Joint Industry Electricity Steering Committee Information Request No. 1.1.0(f) Dated: 08 December 2004 BC Hydro Response issued 20 December 2004	Page 1
British Columbia Hydro and Power Authority Call for Tenders for Capacity on Vancouver Island Review of Electricity Purchase Agreement

Joint Industry Electricity Steering Committee Information Request No. 1.2.0(e) Dated: 08 December 2004 BC Hydro Response issued 20 December 2004	Page 1
British Columbia Hydro and Power Authority Call for Tenders for Capacity on Vancouver Island Review of Electricity Purchase Agreement

Figure IR 1.4.0(a)

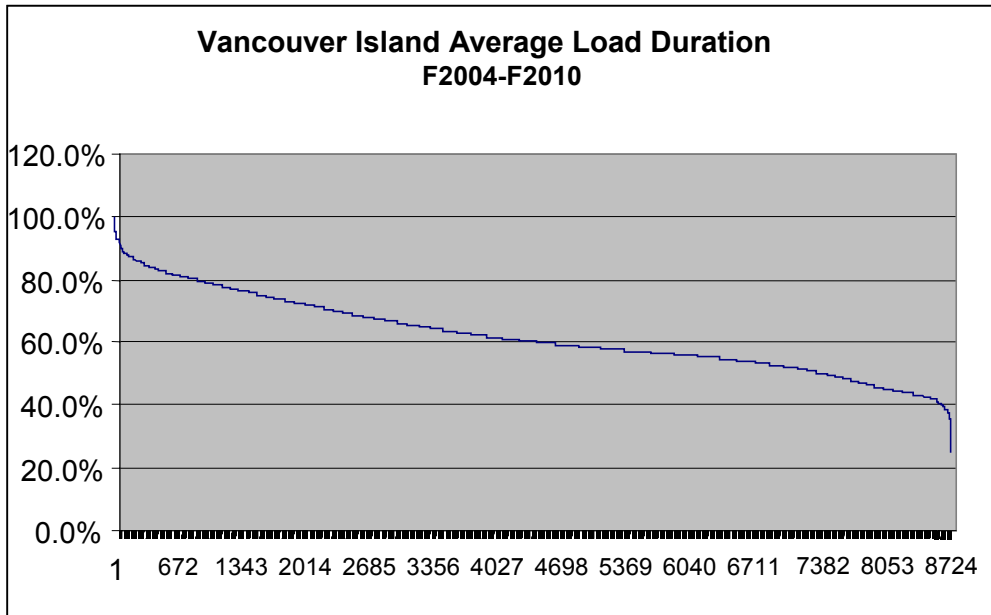
1.4.0(a) Provide the load duration curves for 2004 to 2010 to support the hours required.

BC Hydro does not produce a peak forecast on an hourly basis, so a forecast load duration curve is not available. Figure IR 1.4.0(a) provides a load duration curve for Vancouver Island based on an average over the last five years of actual data.
